BEVELED END SECTIONS
STANDARD PLAN B-70.20-00
 SHEET 1 OF 1 SHEET

SUPPLEMENTAL TO STANDARD PLAN
B-70.20-00

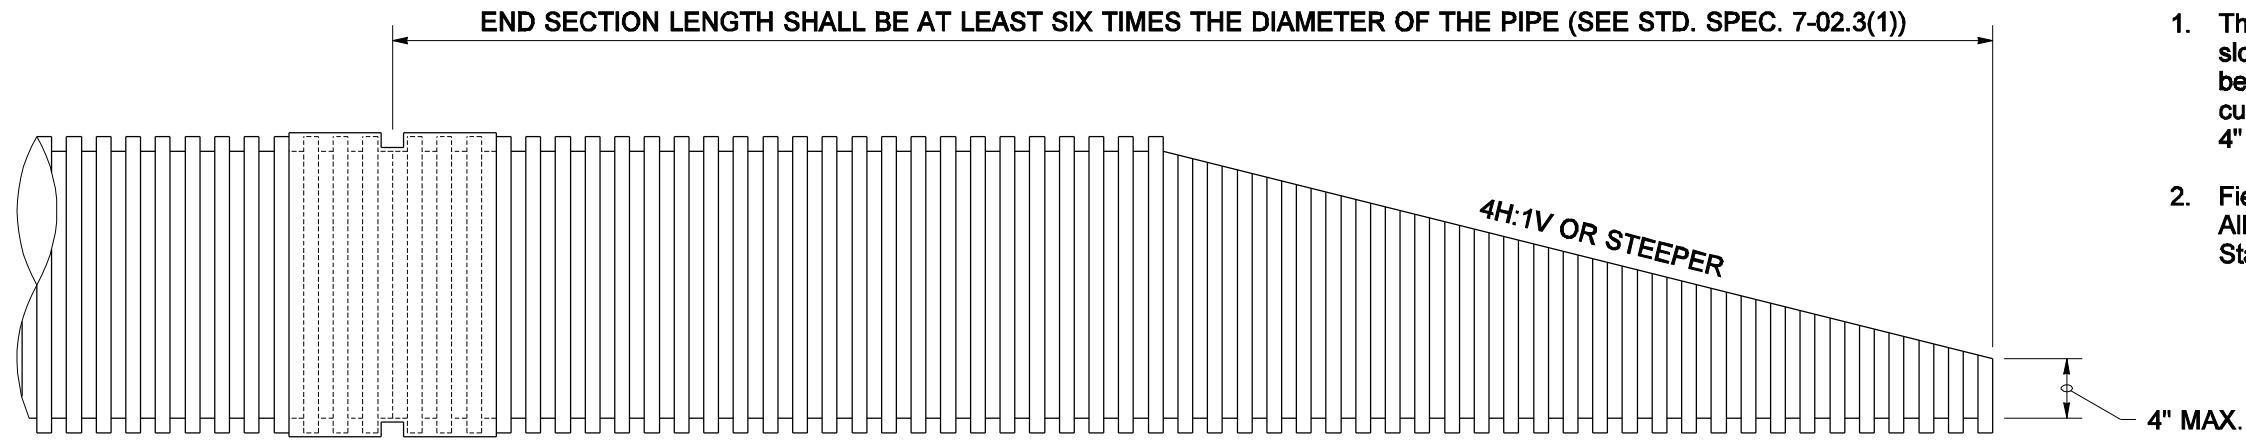
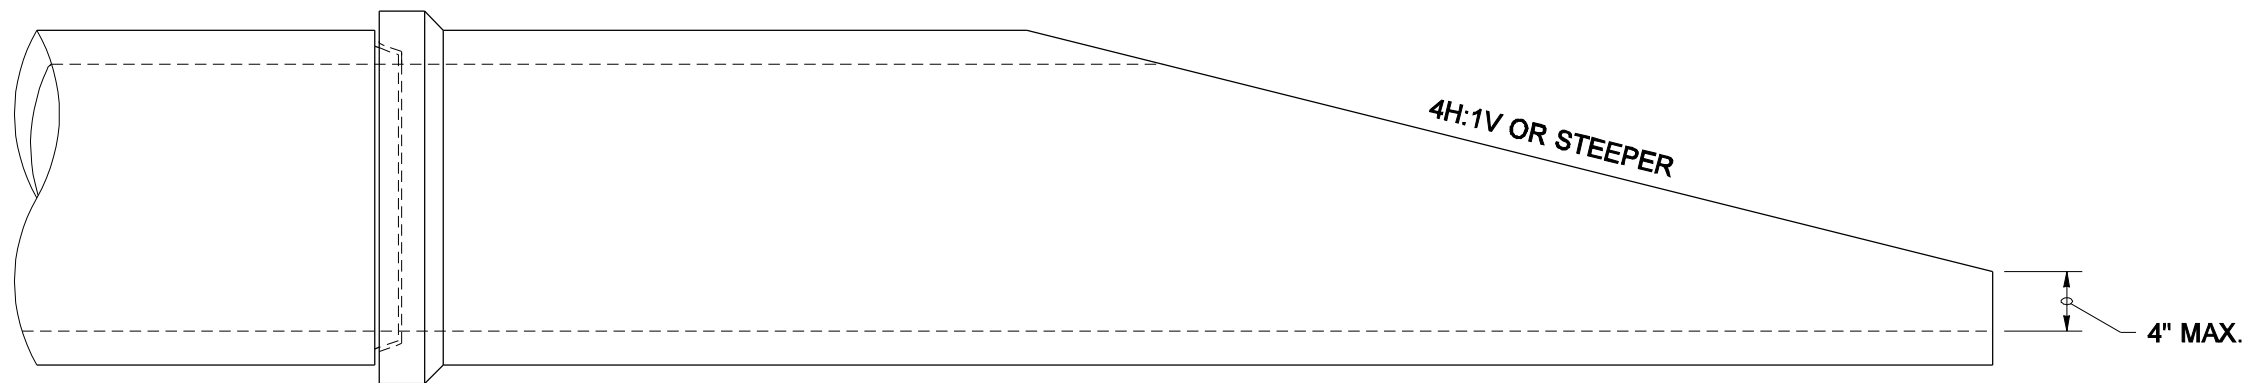
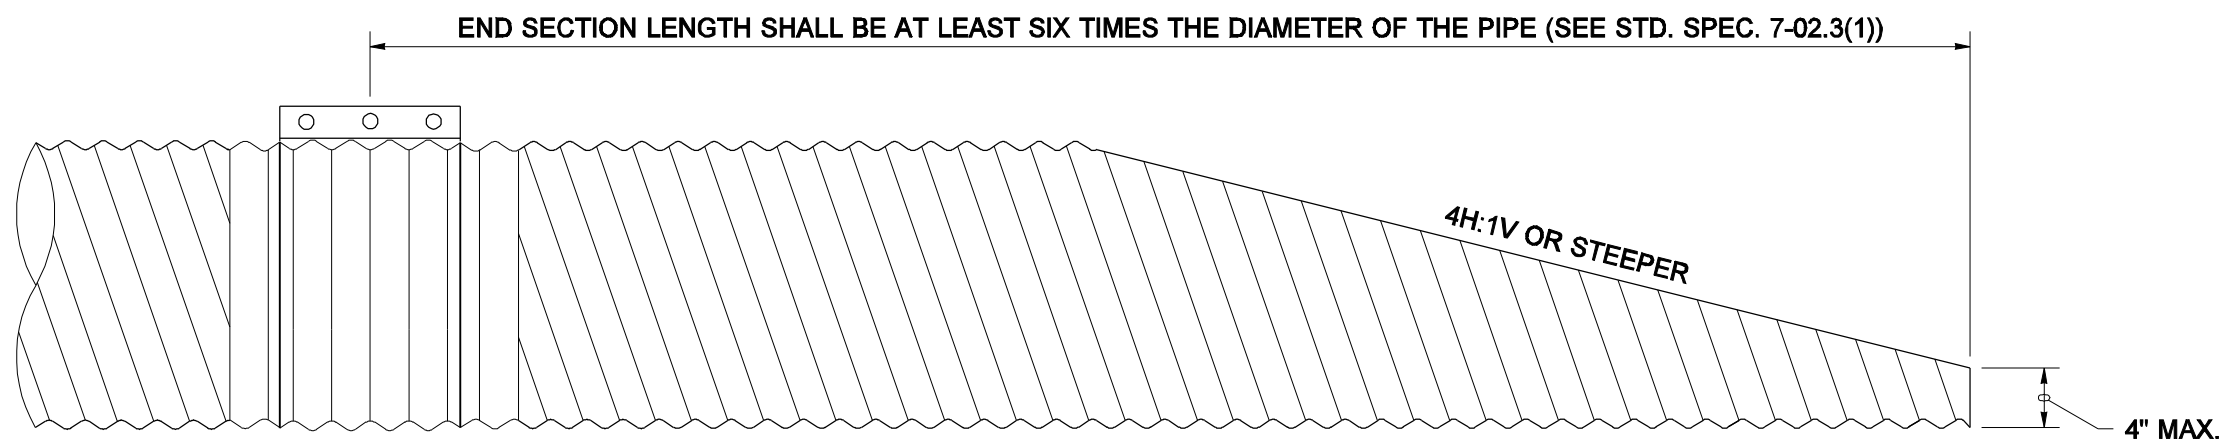
Modify the Standard Plan as follows:

1. A concrete headwall per WSDOT B-75.20-02 and Type 2 safety bars per WSDOT B-75.60-00 shall be installed.
